September 25, 2026

Version 1

Warranty Extension: 2015-17 TLX Fuel Smell from Fuel Fill Pipe (6 Months) - Expires May 31, 2027

FUEL FILL
PIPE ASSEMBLY
CONNECTORS

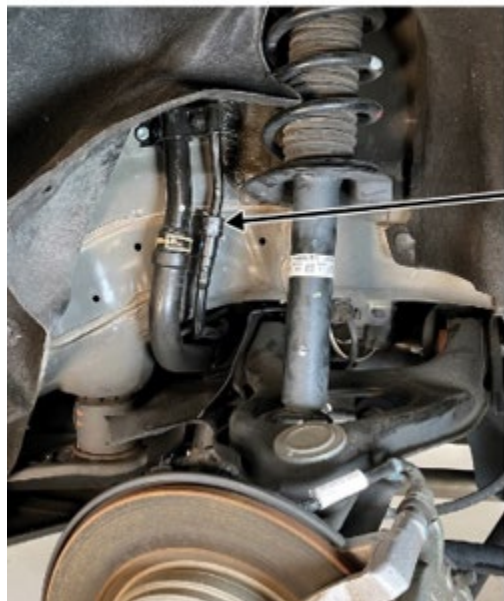
Before disconnecting the fuel fill pipe assembly, use compressed air and a clean shop towel to remove dirt and debris from the area around the fuel fill pipe connectors.

Do not allow debris to enter the fuel tank from the fuel fill pipe assembly. Debris may damage the fuel system.

AIR NOZZLE
Do not allow debris to
enter the fuel tank from
the fuel fill pipes.
